Re: #14ITB93431K-MH
Renovation and Expansion at the Auburn Avenue Research Library

ADDENDUM NO. 1

AUBURN AVENUE RESEARCH LIBRARY

EXPANSION AND MANOR RENOVATIONS

SHEET NUMBER
A-201

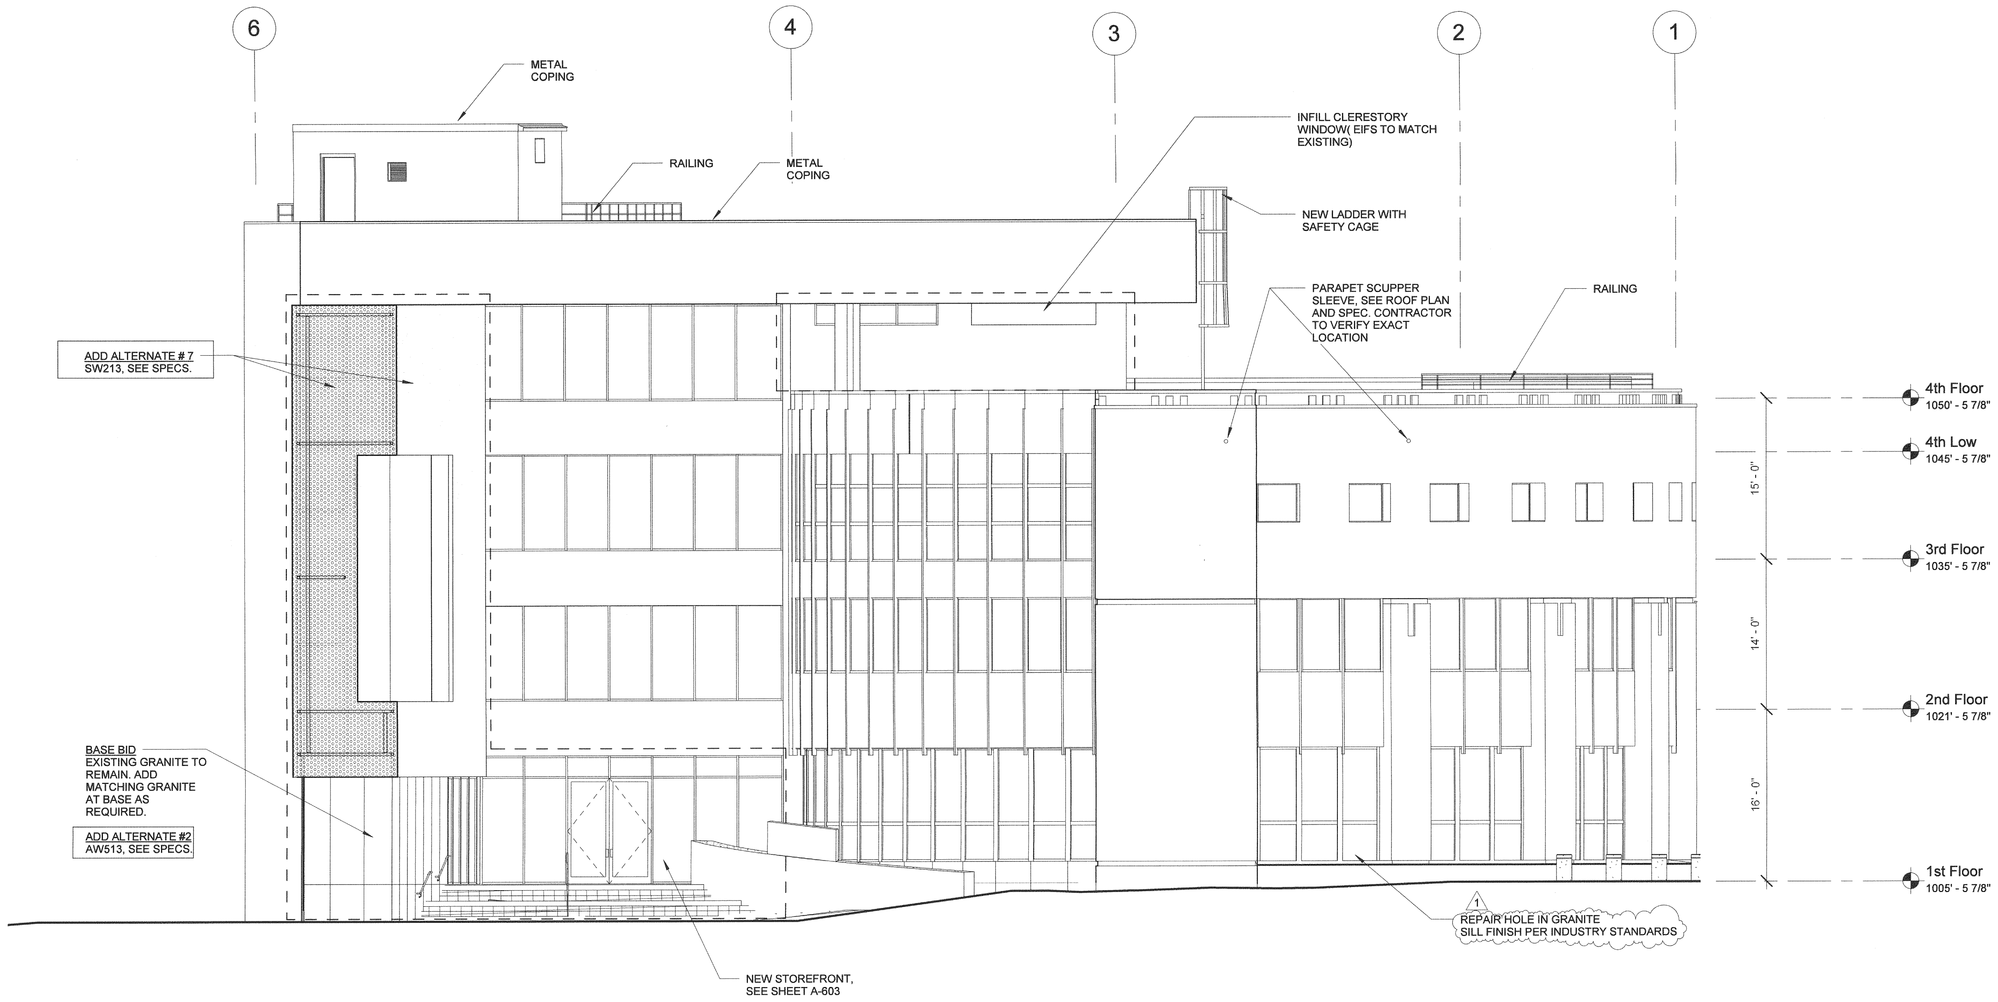
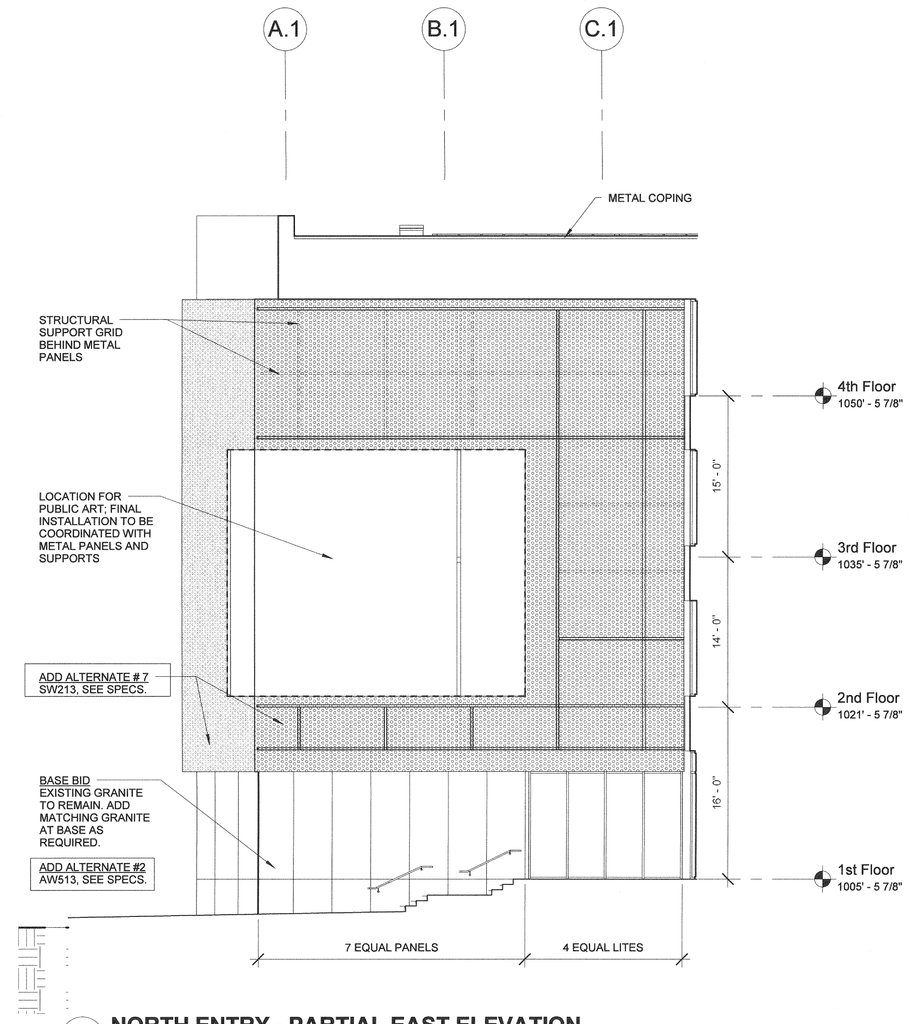
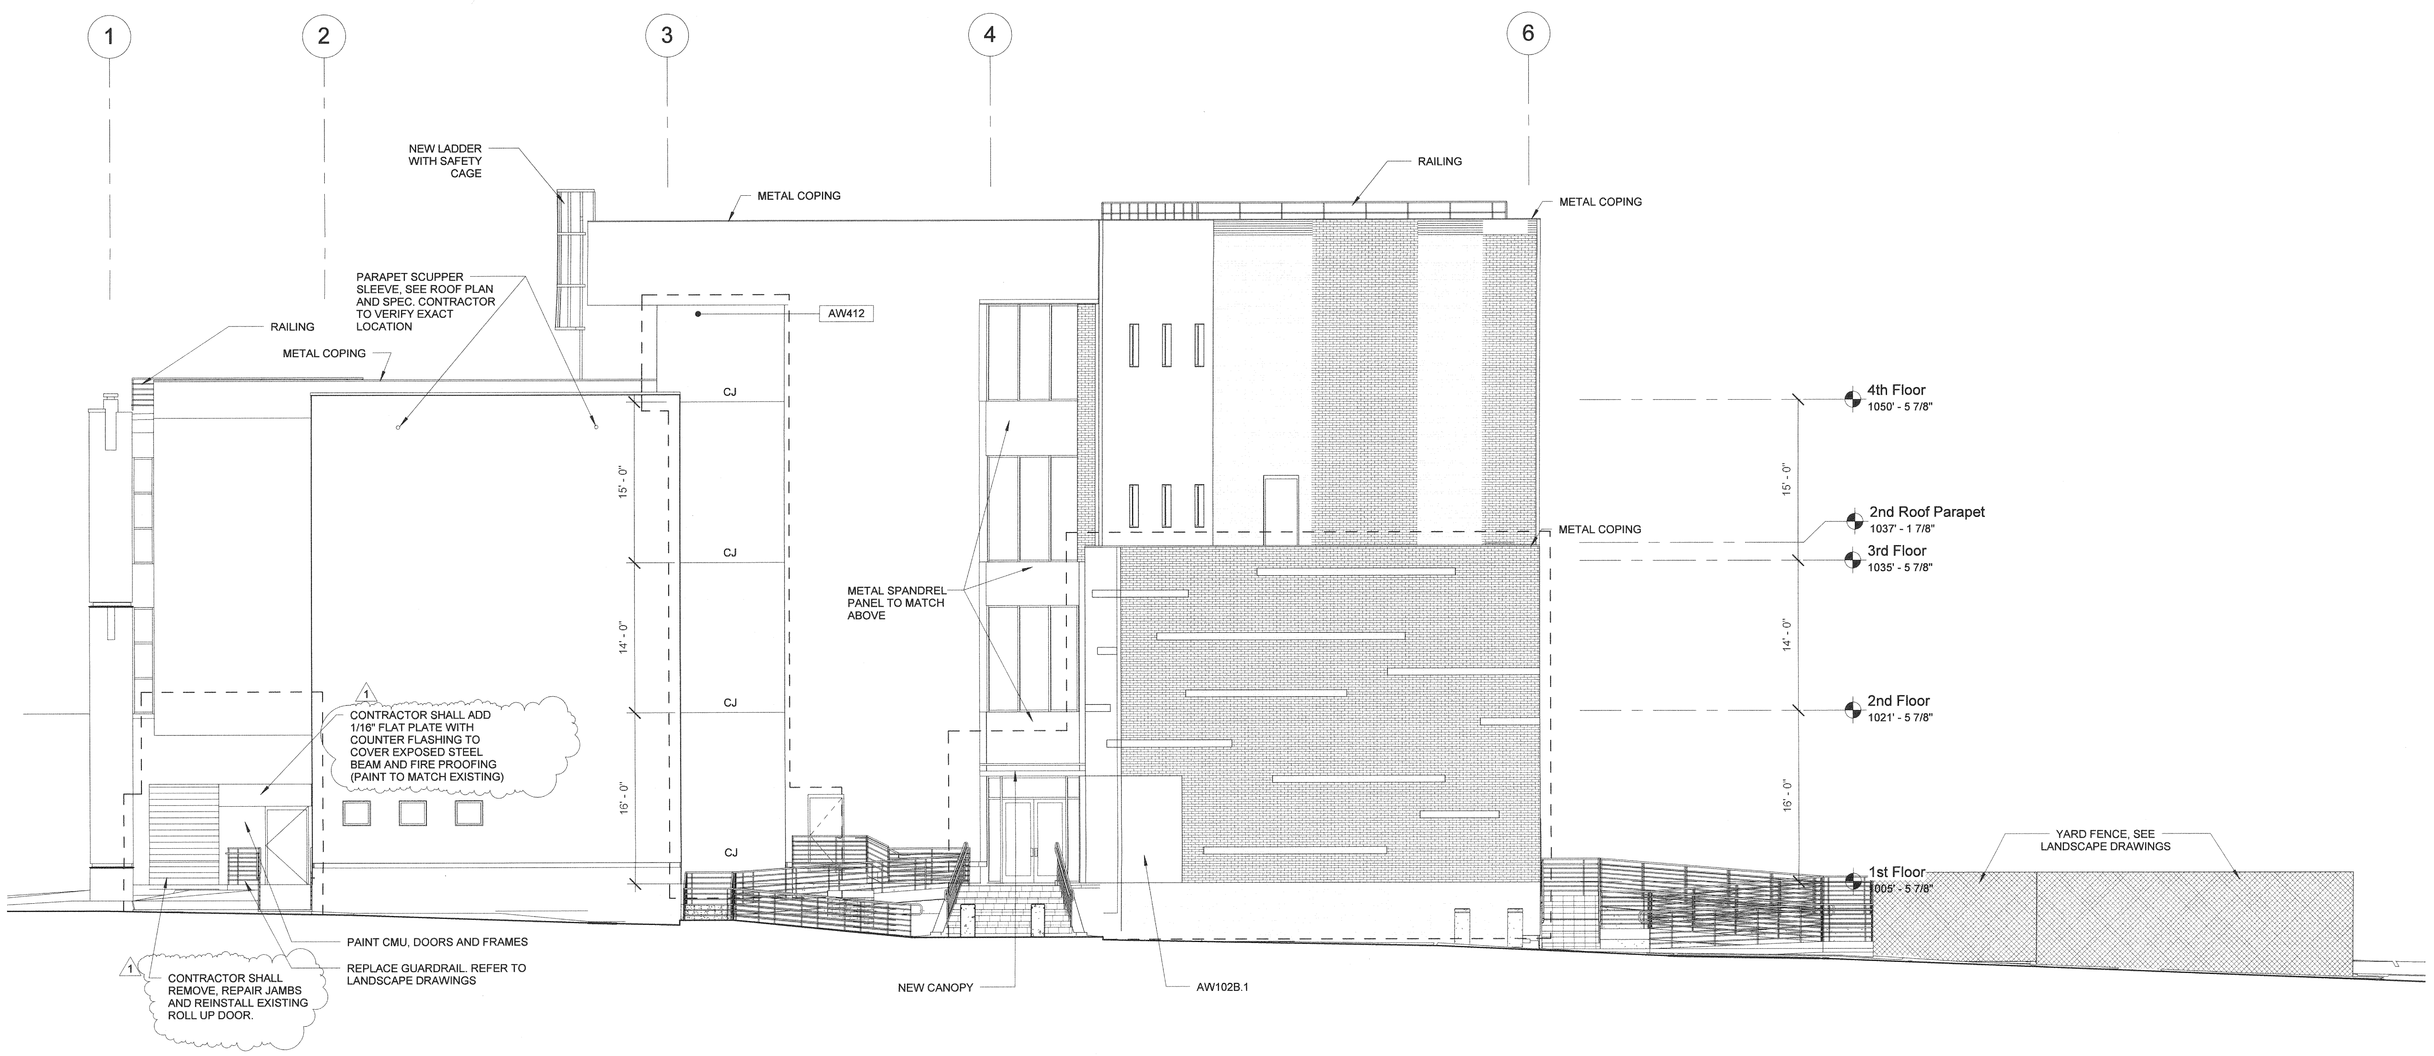
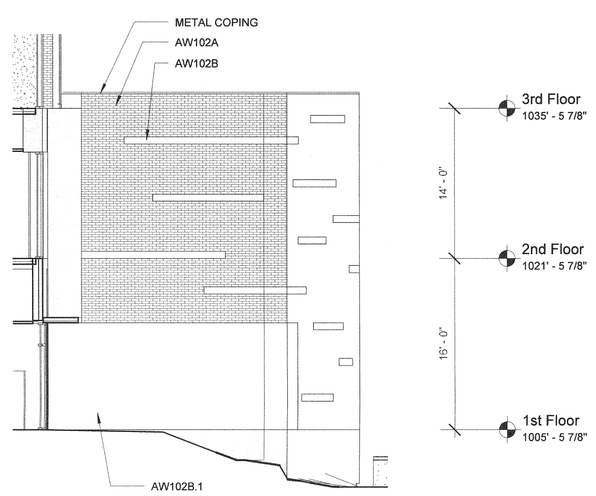
DATE	SHEET	COMMENT	
8/22/2014	L200	3/A-201 refers you to landscape drawings to get more information on replacing guardrail at loading dock. Nothing on landscape drawings refers to this guard rail. This rail does need to be replaced, it has been hit and is bent. Please include a design for this guardrail and if rail can stop when ramp is under 30" tall that would be great.

Answer: Contractor shall cover the exposed fireproofing in the exterior cmu wall with a flat plate anchored to the existing cmu wall. See A201 this Addendum.	
8/22/2014	A-201	Add note to 3/A-201 to paint existing CMU exterior wall by loading dock.

Answer: The Contractor shall remove the damaged pipe rail at the ramp of the loading dock. Reduce the length of the rail approx 15 feet (plus/minus) at the second vertical that is about 30 inches above the ramp. Paint the ramp at this location yellow to identify the ramp.	
8/22/2014	A-201	3/A-201 does not show the exposed steel beam/fireproofing in CMU wall on exterior of building. This needs to be covered with masonry or another exterior wall system. Need details showing how to cover this beam.

Answer: Note shown to paint, cmu, jambs and doors on documents. See A-S201 this Addendum.	
8/22/2014	A-101-D thru A-104-D	Add note to Stair #2 and Stair #4 to remove all loose cables/cables in stairwells.

2 A-202 **WEST ELEVATION - NEW**
1/8" = 1'-0"

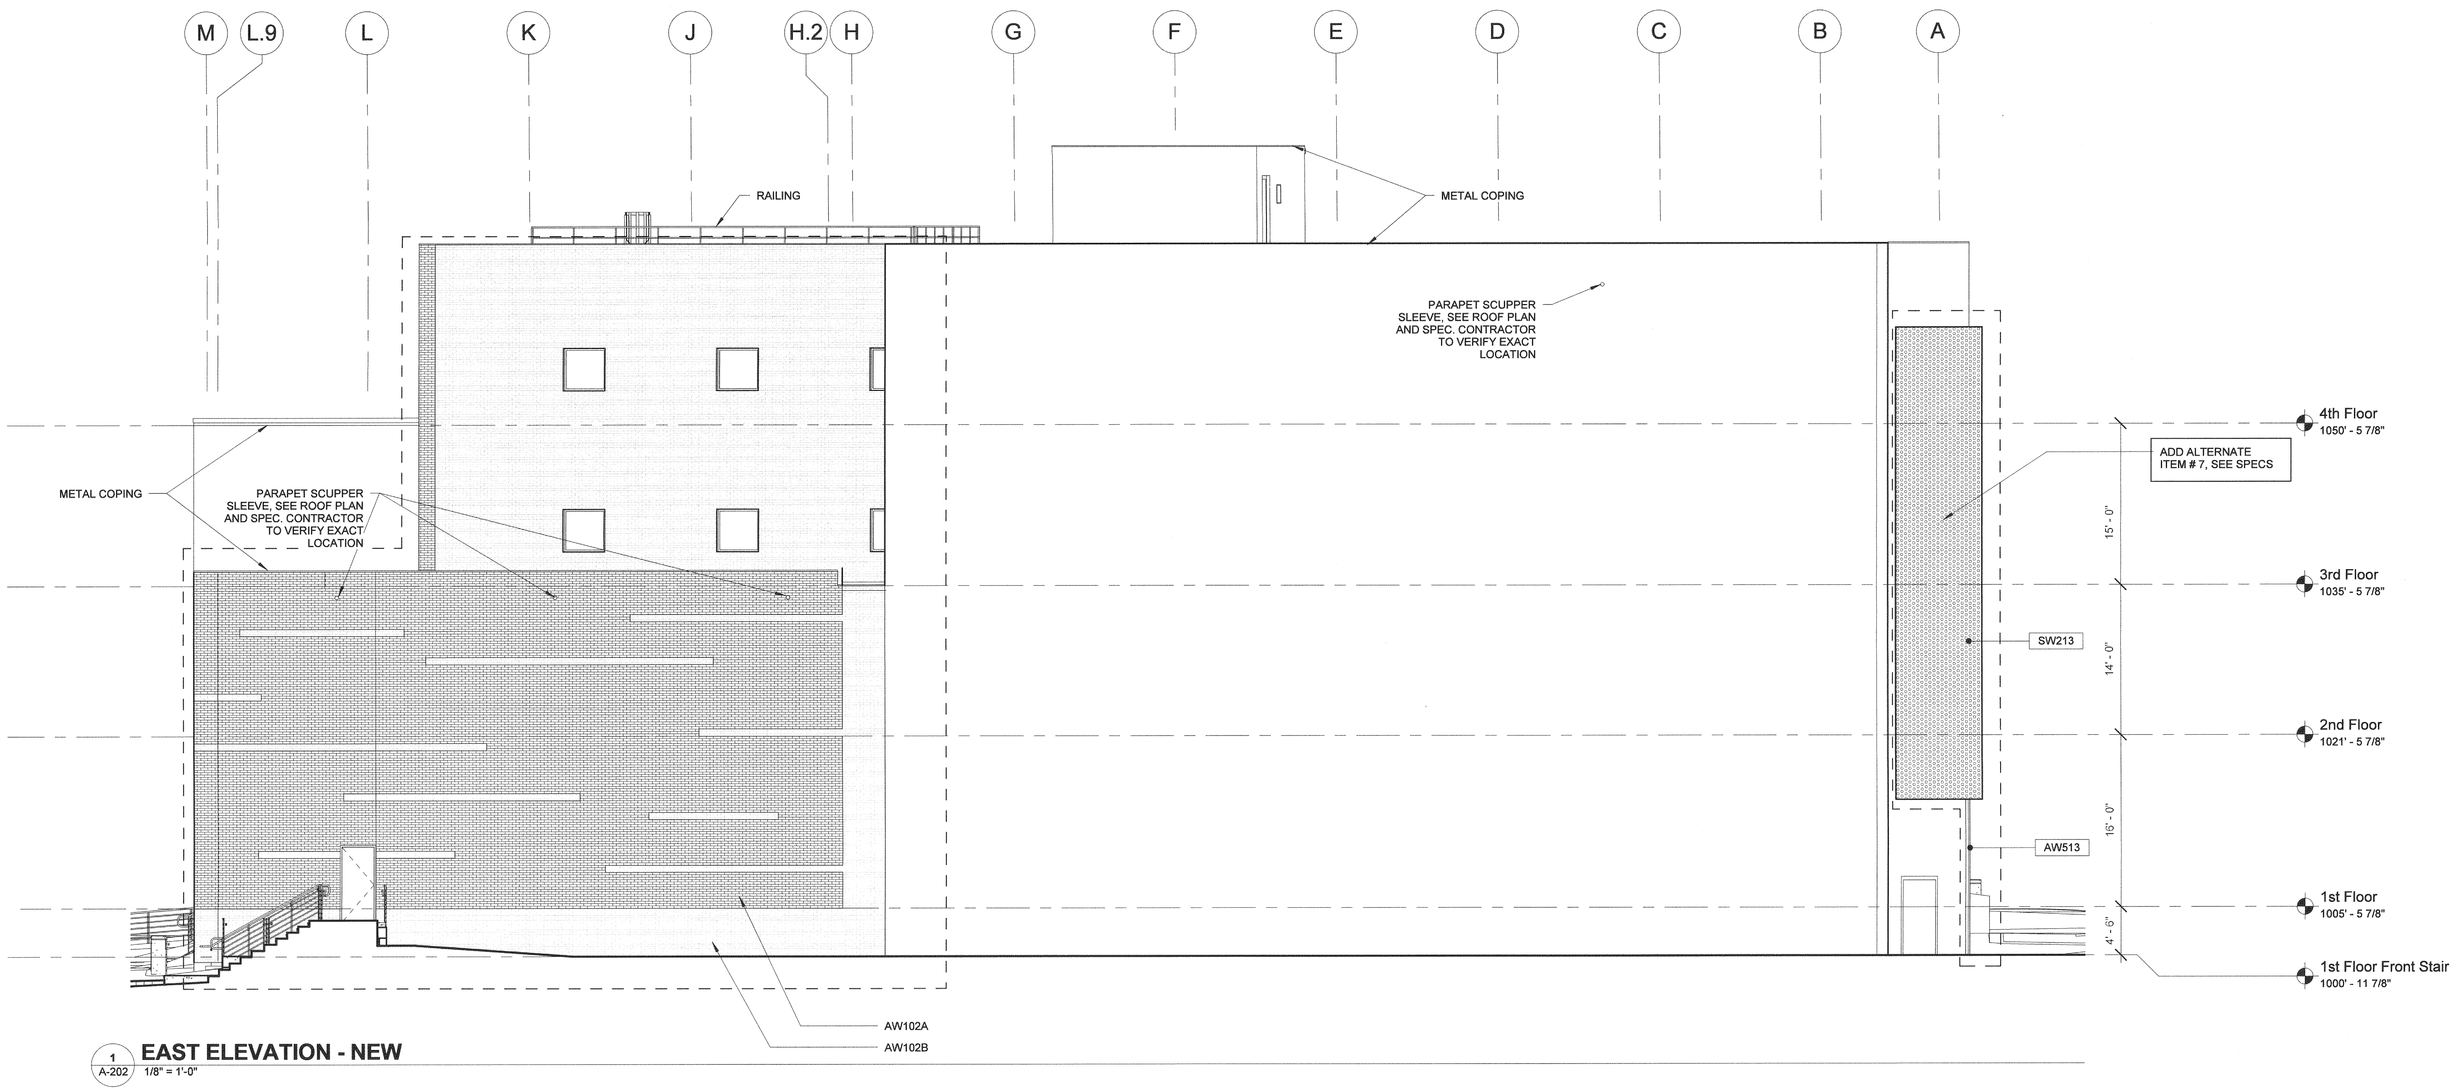
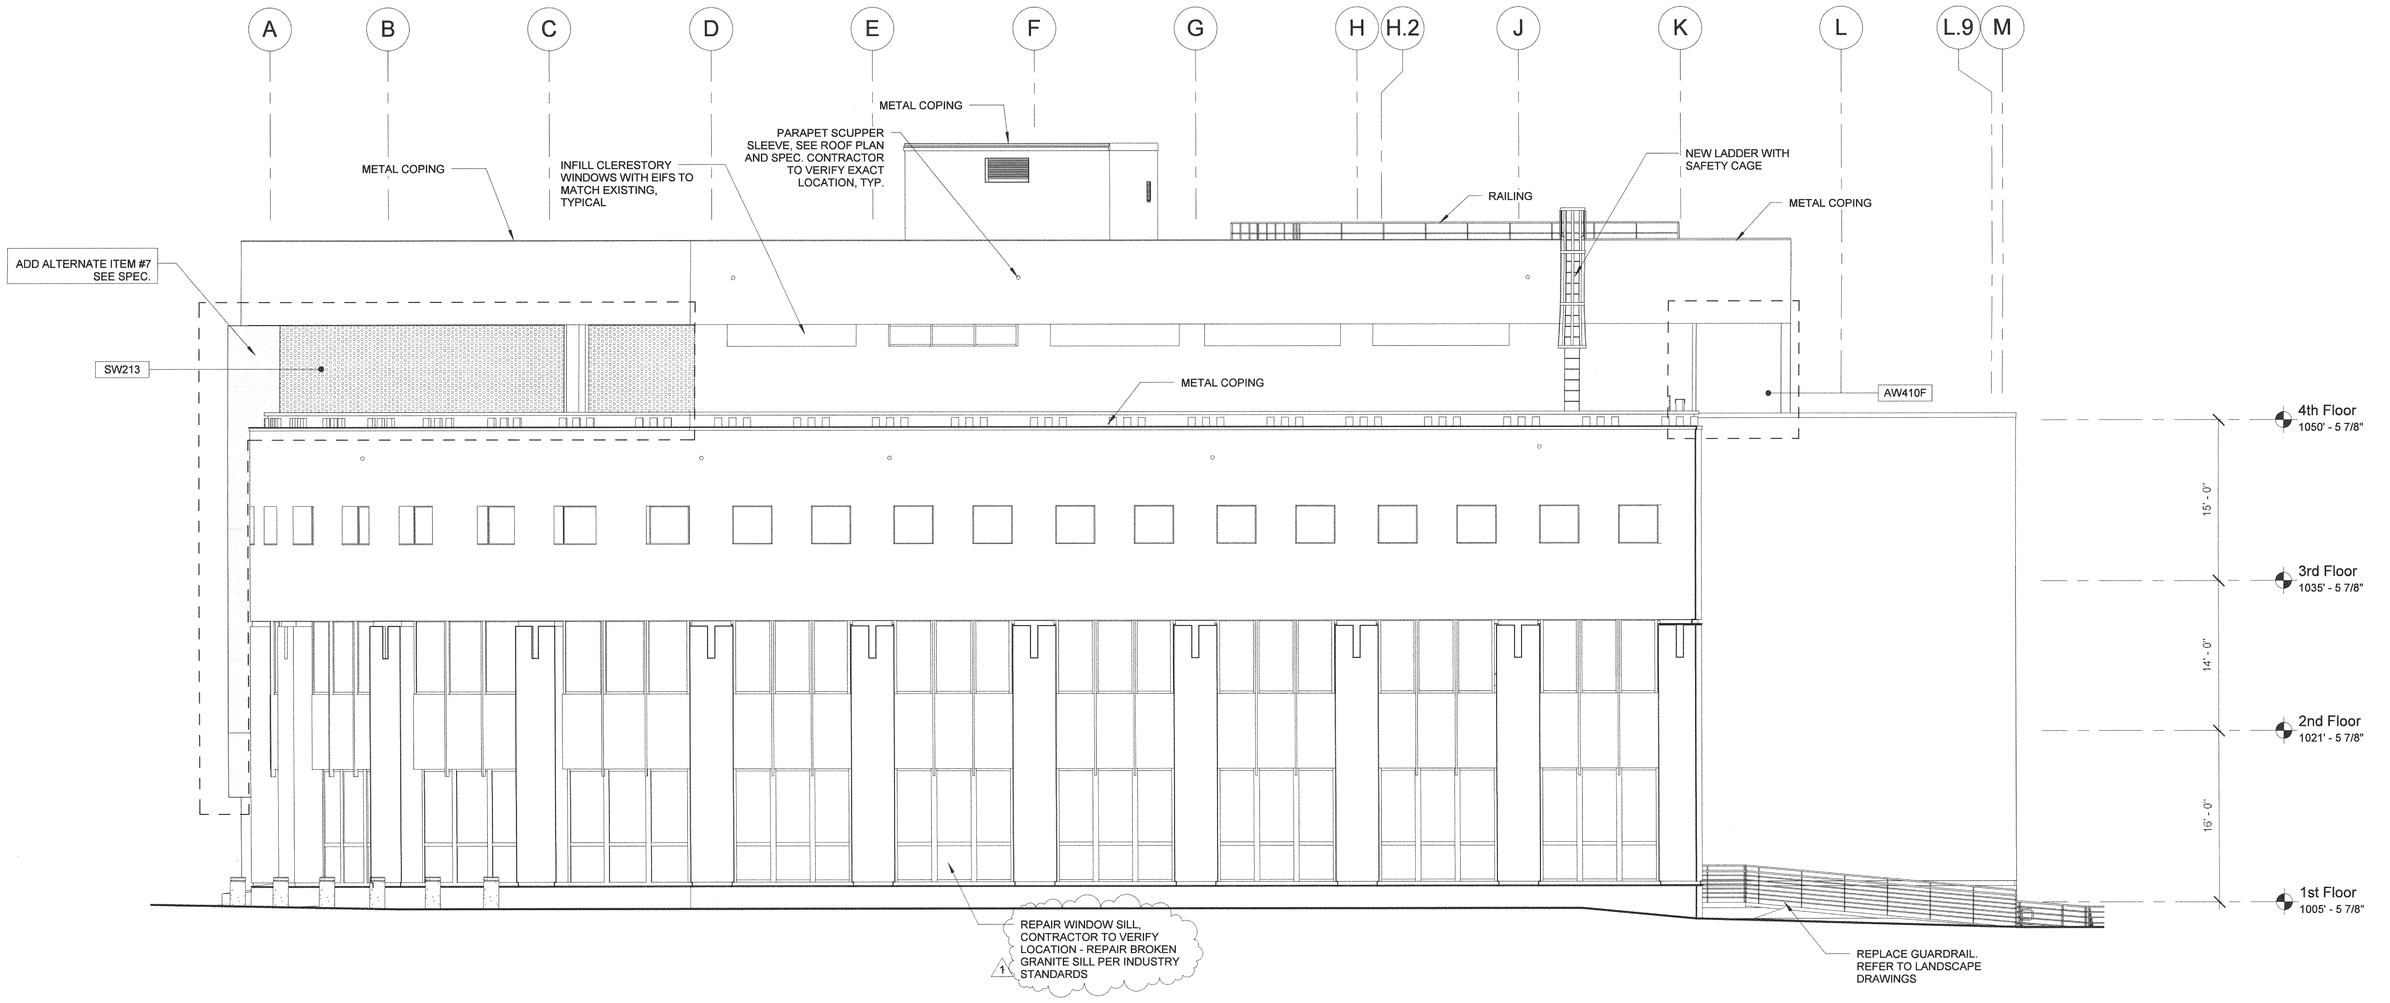
Answer: Note shown on documents to remove all loose cables/cables in stairs.	
9/9/2014	A-202	Add to note on elevation 2/A-202 - to repair "black granite" sills on Courtland. JWRA to advise and provide an acceptable repair detail.

Answer: The Contractor shall patch and repair the broken granite window sill on the west elevation. The patch repair and finish per the industry standards. See drawings A201 and A202.	
9/9/2014	A-102-D & A-103-D	Floor box is located within the wall that runs from column D1 to column D2 on floors 2 & 3. These boxes need to be demoed or relocated and walls repaired.
